# Work Order ID 79744

Item Name: Crosstube Turning Detail

<b>DART AEROSPACE LTD</b>	<b>Work Order:</b> 79744
<b>Description:</b> Crosstube Assembly	<b>Part Number:</b> D407-667-245
<b>Inspection Dwg:</b> D407-667-245 <b>Rev:</b> F	<b>Page 1 of 1</b>

DRAWING NO. D407-667-245	TITLE CROSSTUBE ASSY (407 HIGH AFT)	REV. F	DART AEROSPACE LTD ENGINEERING ORDER		D.E.O. NO. D407-667-245-F-1	SHEET NO. SHEET 1 OF 2	SCALE NTS
DRAWN <i>[Signature]</i>	CHECKED <i>[Signature]</i>	MFG. APPR. <i>[Signature]</i>	APPROVED <i>[Signature]</i>		DE APPR. <i>[Signature]</i>		
DATE 11.04.08	DATE 11.04.12	DATE 11.04.12	DATE 11.04.12		DATE 11.04.12

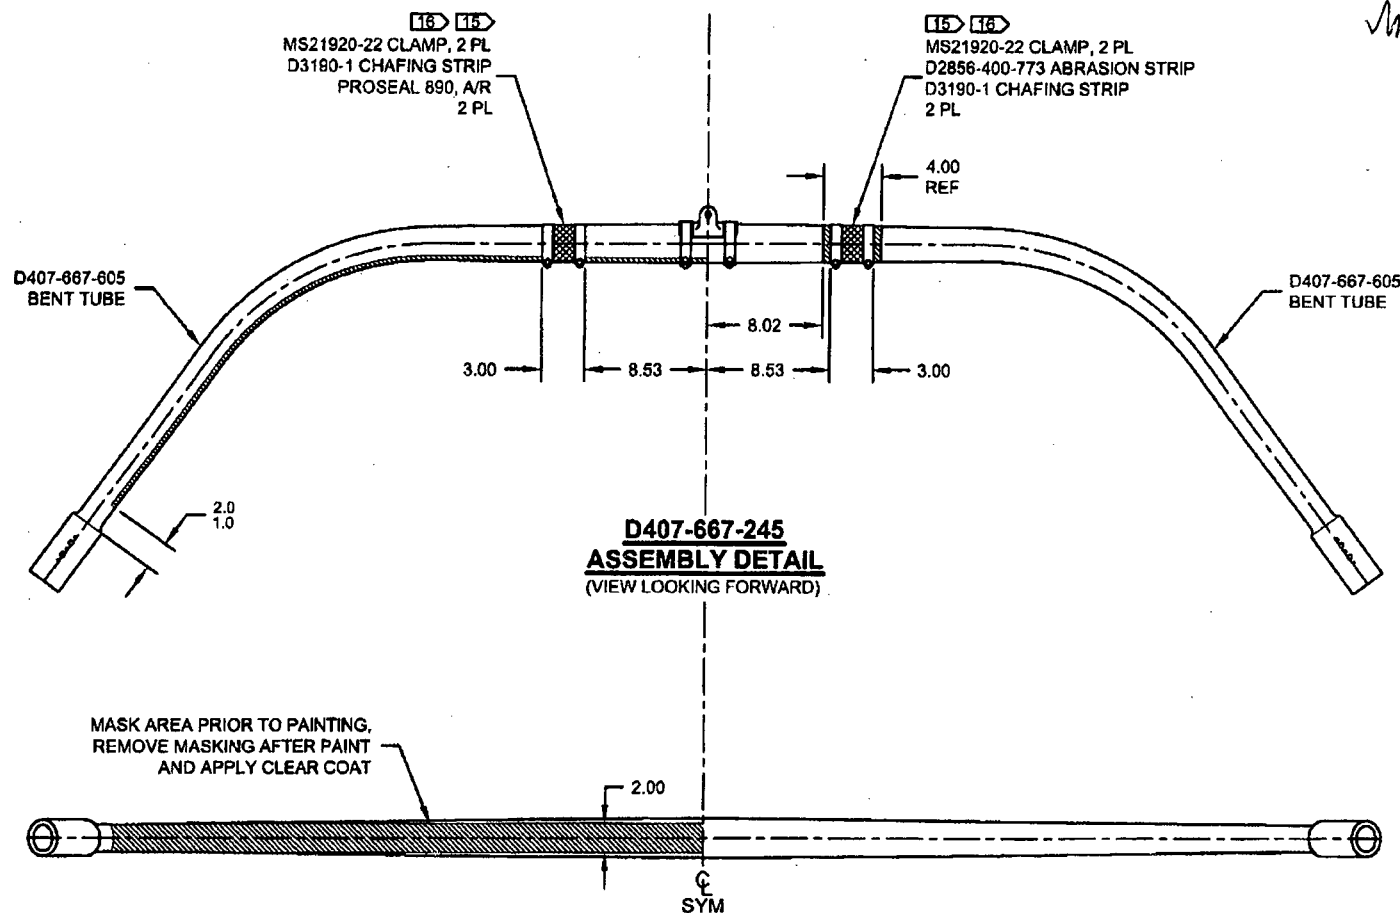
**PURPOSE:**

REMOVED ABRASION STRIP IN FAVOR OF A THIN LAYER OF PROSEAL 890.

NOTES 2 AND 15, SHEET 1 ARE AMENDED AS FOLLOWS:

**IS:**

- 2) FINISH: CHEMICAL CONVERSION COAT PER DART QSI 005 4.1  
PRIME INSIDE AND OUTSIDE PER DART QSI 005 4.2  
MASK UNDERSIDE OF CROSSTUBE AS SHOWN (HATCHED AREA) AND  
PAINT OUTSIDE PER DART QSI 005 4.2  
REMOVE MASKING AND APPLY CLEAR COAT
- 15) APPLY A THIN COAT OF PROSEAL 890 ON INSIDE CONCAVE SURFACE OF D3190-1  
CHAFING SHIELDS AND LET CURE PER MANUFACTURER'S INSTRUCTIONS. INSTALL  
PROSEAL D3190-1 CHAFING SHIELDS ONTO CROSSTUBE BY APPLYING A THIN COAT  
OF PROSEAL 890 ONTO CROSSTUBE. BE SURE TO ELIMINATE ANY AIR GAPS.

**WAS:**

- 2) FINISH: CHEMICAL CONVERSION COAT PER DART QSI 005 4.1  
PRIME INSIDE AND OUTSIDE PER DART QSI 005 4.2  
PAINT OUTSIDE PER DART QSI 005 4.2
- 15) INSTALL D2856-400-773 ABRASION STRIP WITH A 0.13 REF GAP ON BOTTOM SIDE OF  
CROSSTUBE PER QSI 035.
